**COMMENTS AND RESPONSES
ON 3rd MEMBER ORGANIZATION BALLOT
January 21, 2009 to March 6, 2009
PROPOSALS**

PUC Note: *On March 26, 2009, during the PUC meeting to resolve the comments of the 3rd Member Organization Ballot, the PUC, having consulted with the BSSC Board chair, concluded that a member ballot including YR or N on 15 of the 20 proposals could not be counted in the tally on those items because no explanation or reason for the YR or N votes was provided.*

PART 1 PROPOSALS

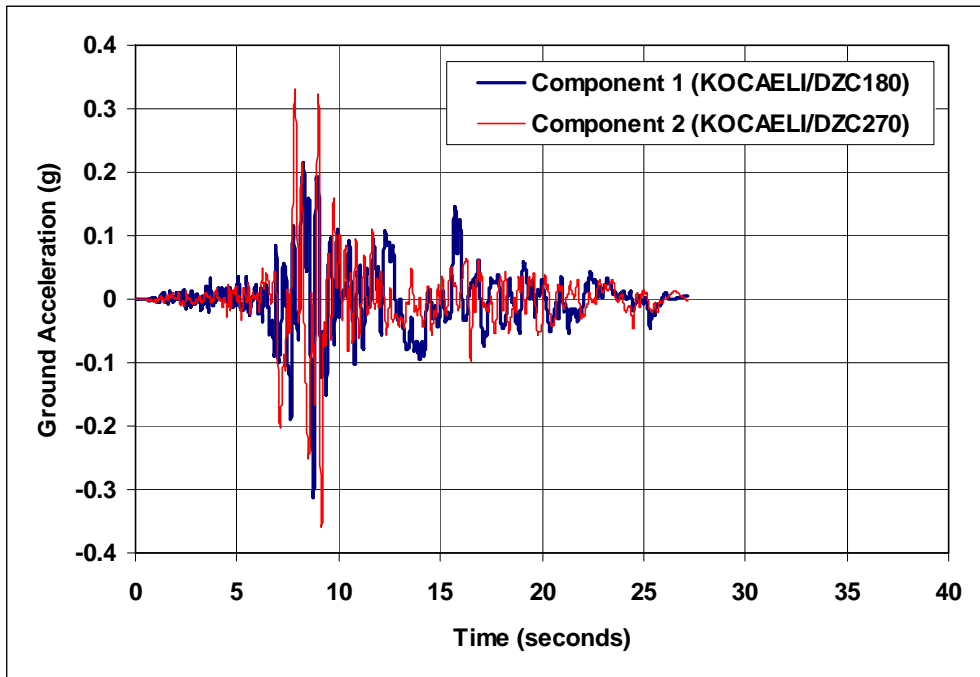
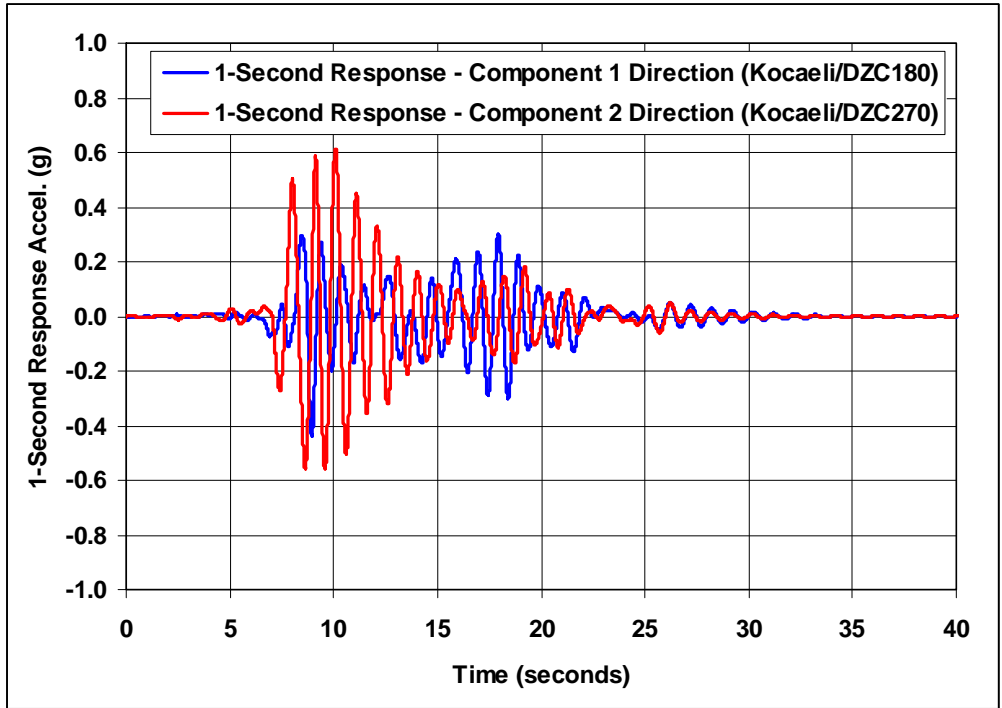
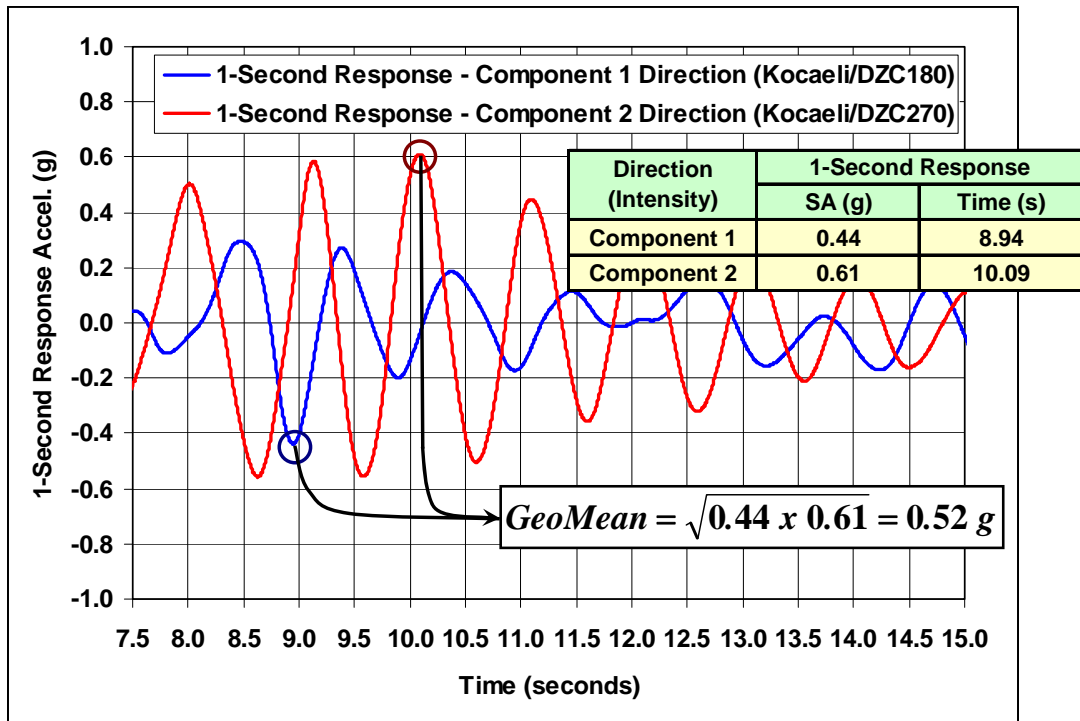
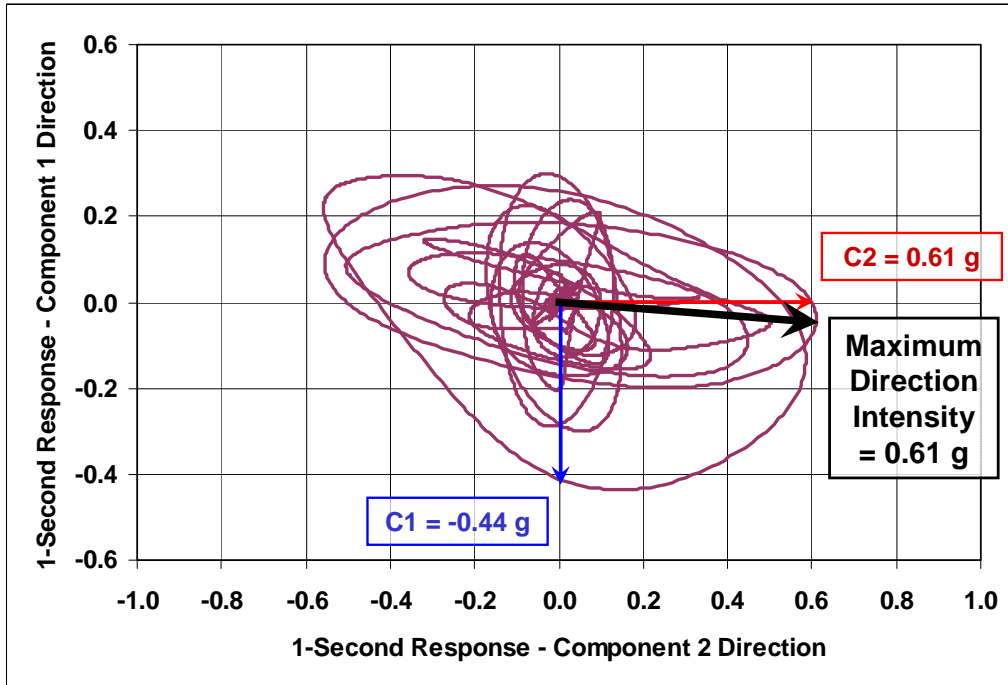
The EERI letter states that the geometric mean is the average of horizontal motions in log unit. This statement is misleading, assumes that spectral ordinates alone are sufficient to characterize ground motion, and ignores the temporal correlation (or lack thereof) between spectral responses to orthogonal components of ground motion. For illustration, consider the two components of horizontal ground motions from the 1999 Kocaeli earthquake (Duzce record) shown in Figure R-1. In this case, the two components are shown in their as-recorded orientation. The first step in calculating the geometric mean is to separately calculate the response of 5%-damped SDOF system to each component at the period of interest. This is shown in Figure R-2 for response at a period of 1-second and the strongest portion of 1-second response is shown in Figure R-3. The next step involves finding the peak response of each component that generally occur at different points in time, as shown in Figure R-3. The geometric mean is then calculated as the square root of the product of the two, non-coincident (absolute) values

of peak response. The geomean may be a convenient method of combining peak responses from the two orthogonal directions, but it has no physical meaning. From a statistical standpoint, averaging the two orthogonal directions, reduces some of the scatter (uncertainty) associated with peak response of an individual component. That is, two records with the same geomean intensity could have very different values of peak response in the two directions (at different points in time).

In contrast to the geometric mean, the maximum direction combines the two directions of response in a physically realizable process, that is, as the resultant response of a bi-directional SDOF. Figure R-4 illustrates this calculation by plotting coupled response of the 1-second system in the X-Y plane. Note: Rotating the axes (but not the record trace) changes the peak response values of the two components (C1 and C2) that are measured along their respective axes, but not the peak resultant (maximum direction intensity). We recognize the inherent limitations of response spectra that are based on peak response of a linear-elastic SDOF system (hardly the most realistic representation of most structures), but given these limitations, feel that the maximum direction intensity provides a more appropriate and realistic measure of peak response at the period of interest.

Figure R-5. Comparison of geometric mean spectra – (all) 11 strike-slip records in the PEER NGA database of $M_w > 7$, $D_f < 20$ km, 180 m/sec $< v_{s,30} < 760$ m/s and NGA ground motions based on site/source properties of individual records (Atik. PEER, spreadsheet, 1/3 BA08, 1/3 CB08, 1/3 CY08)

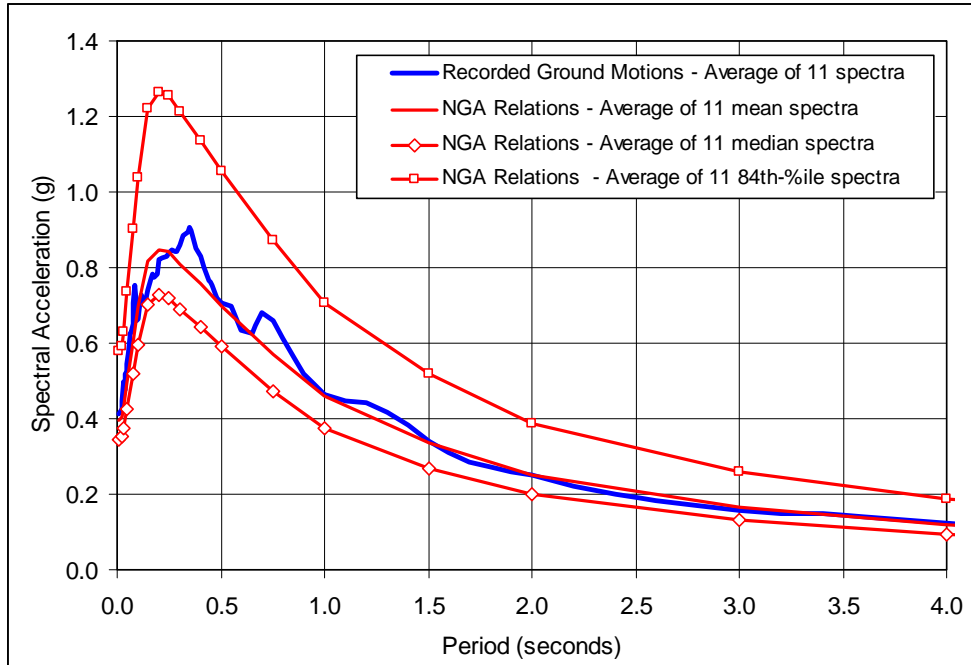
Figure R-5 compares response spectra of the 11 recorded ground motions with NGA ground motions predicted for the same magnitude, fault type, site-source distance and site shear wave velocity as each record (using a PEER spreadsheet, and the same relations/weighting factors as those used by the USGS to develop hazard functions). Two important points. First, mean NGA ground motions are slightly lower, on average, but reasonable representations of the mean of recorded ground motions. Second, the mean of recorded data is not well known due to the paucity of records (only 11 records).
